ADDENDUM NO. 4

RFQ CCC-056

**New Student Services Building
Compton Community College District**

tBP Project. No. 20987.00

TELECOM CONDUIT RISER DIAGRAM

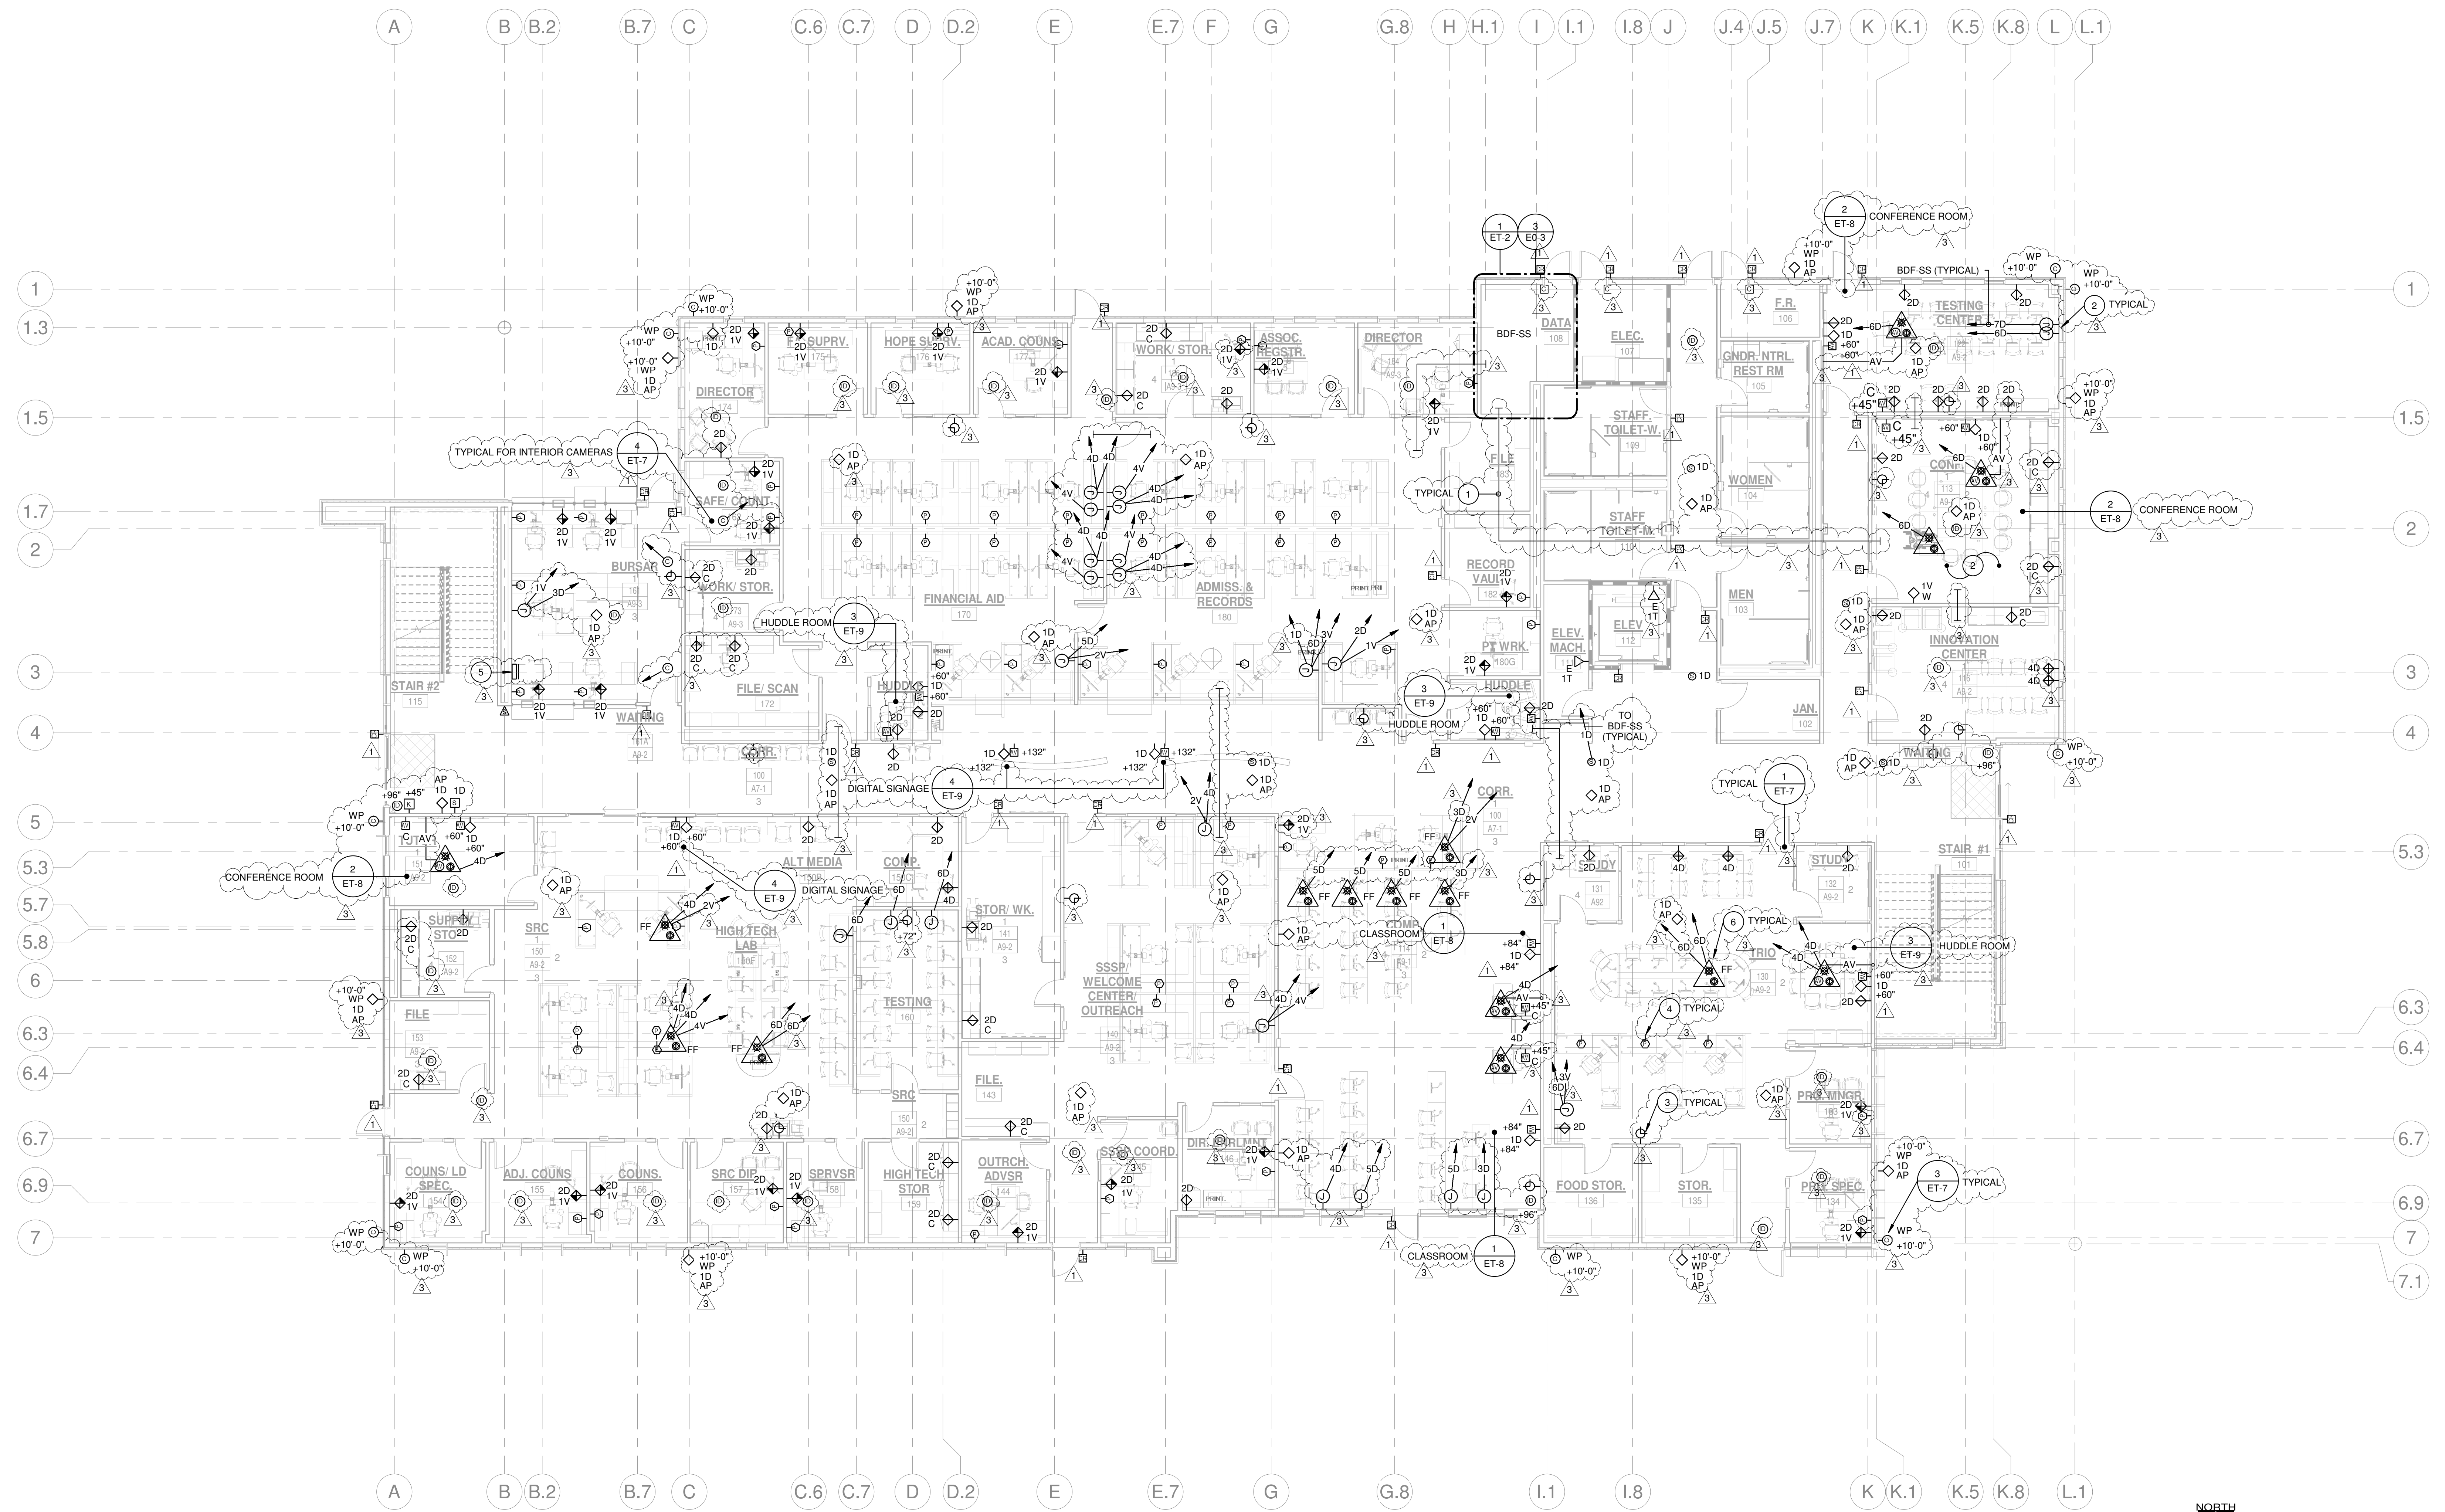
34. Revised SHEET ET-2 ENLARGED TELECOM ROOMS
 - a. Add rack elevations.
35. Revised SHEET ET-3 TELECOM SYSTEM RISER DIAGRAMS
 - a. Revised Telecom Conduit Riser Diagram "D".

drawing no.:
ET-5
drawing of

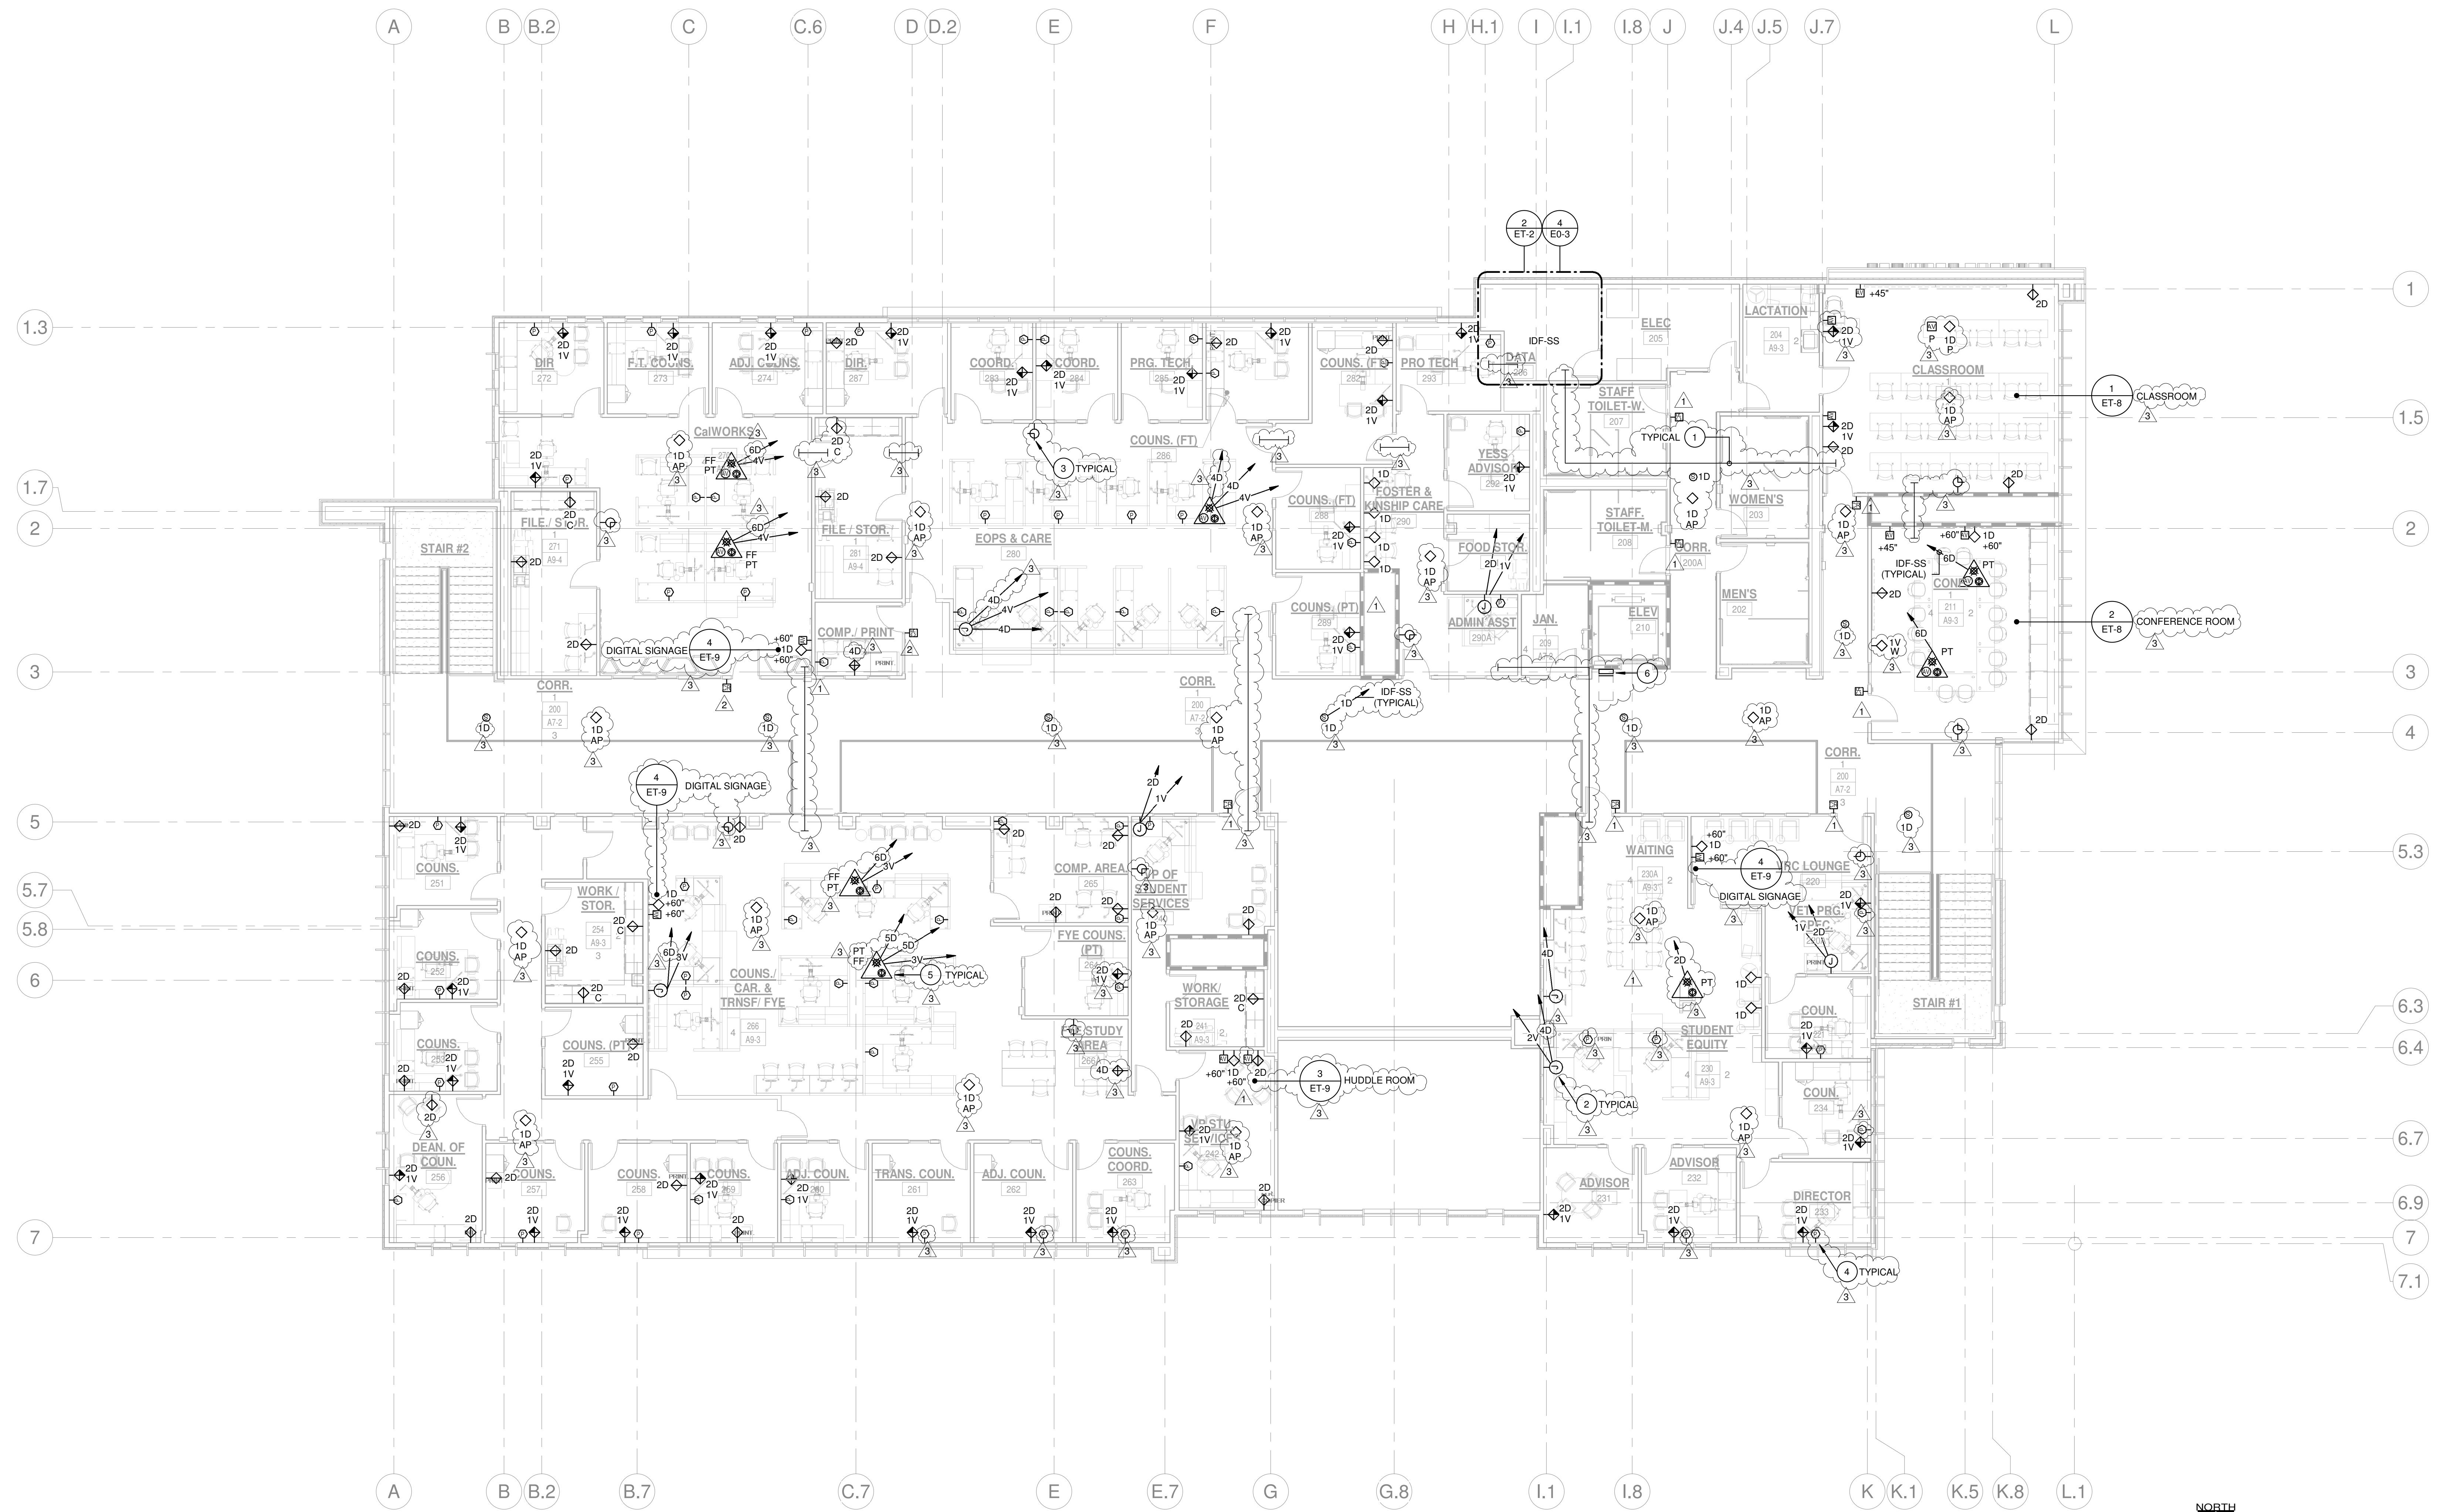
36. Revised SHEET ET-5 1ST FLOOR TELECOM PLAN
 - a. Revised Telecommunications Plan.
 - b. Add Plan Notes.
37. Revised SHEET ET-6 2ND FLOOR TELECOM PLAN
 - a. Revise Telecommunications Plan
